<b>Title - Sujet</b> Portable Maintenance Shed	
<b>Solicitation No. - N° de l'invitation</b> F1782-19C066/A	<b>Amendment No. - N° modif.</b> 001
<b>Client Reference No. - N° de référence du client</b> F1782-19C066	<b>Date</b> 2020-01-14
<b>GETS Reference No. - N° de référence de SEAG</b> PW-\$VIC-256-7904	
<b>File No. - N° de dossier</b> VIC-9-42195 (256)	<b>CCC No./N° CCC - FMS No./N° VME</b>
<b>Solicitation Closes - L'invitation prend fin</b> <b>at - à 02:00 PM</b> <b>on - le 2020-02-18</b>	
<b>Time Zone</b> Fuseau horaire Pacific Standard Time PST	
<b>F.O.B. - F.A.B.</b> <b>Plant-Usine:</b> <input type="checkbox"/> <b>Destination:</b> <input type="checkbox"/> <b>Other-Autre:</b> <input type="checkbox"/>	
<b>Address Enquiries to: - Adresser toutes questions à:</b> Morton, Chris	<b>Buyer Id - Id de l'acheteur</b> vic256
<b>Telephone No. - N° de téléphone</b> (250) 580-1311 ( )	<b>FAX No. - N° de FAX</b> ( ) -

## SOLICITATION AMENDMENT

Solicitation Amendment 001 is issued to address bidder enquiries and adjust the mandatory technical criteria and warranty period. The solicitation closing date will be extended to 18 February 2020.

Photos 1-3:

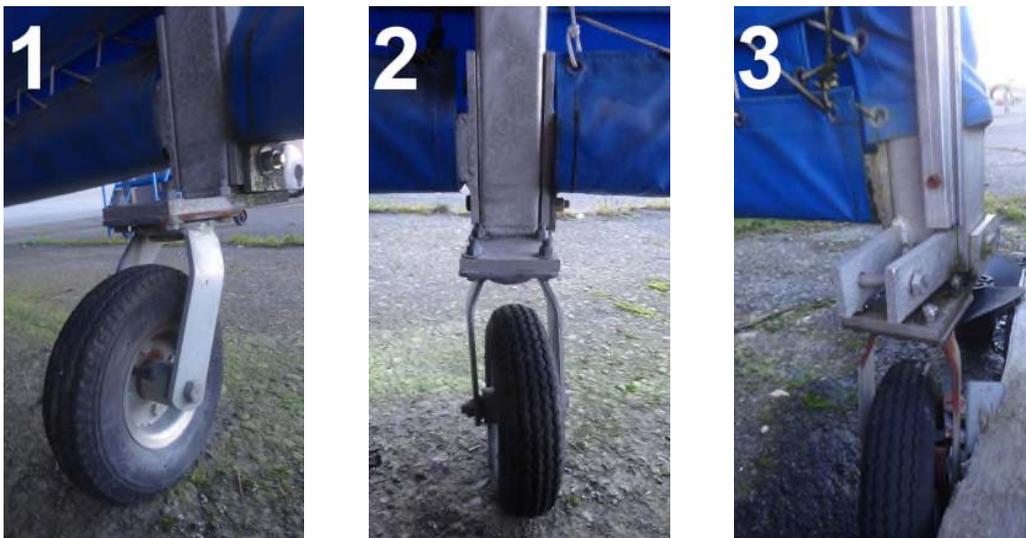
- Q3: Do the garage doors and service doors require installation?
- A3: No, the doors do not require installation.
- Q4: Can you provide details regarding the foundation frame (supplied by others) that the building will be anchored to? Specifically, the height of the frame off grade. Would providing a plate that can be welded/bolted to your frame that is approximately 33cm (13") be acceptable?

- A4: Item B2 in Annex D states "Must include flanges welded or fastened to the bottom of the frame to allow the structure to be anchored to the pavement below". The intention of this line is to say that

flanges can be removable, or fixed to the structure to allow it to be anchored to the existing concrete/pavement parking lot where the structure will be situated. The existing concrete is in the range of 15.2cm – 20.3cm (6" to 8"), with an unknown rating as it is vintage 1940's. The corner closest to where the "C" side meets the "B" side might land on a section that is asphalt. Field fit at time of installation.

Portable tents that we use on site fittings that are similar to what we intend, however they have inflatable castors attached to the mounting flange (see Photos 1-3). For this requirement, given that it is bigger, we opted not to use castors but mounting flanges (with holes) as a preferred way to mount to the anchors embedded into concrete/asphalt. We purposely did not go into great detail on this because we understand that manufacturers have different configurations.
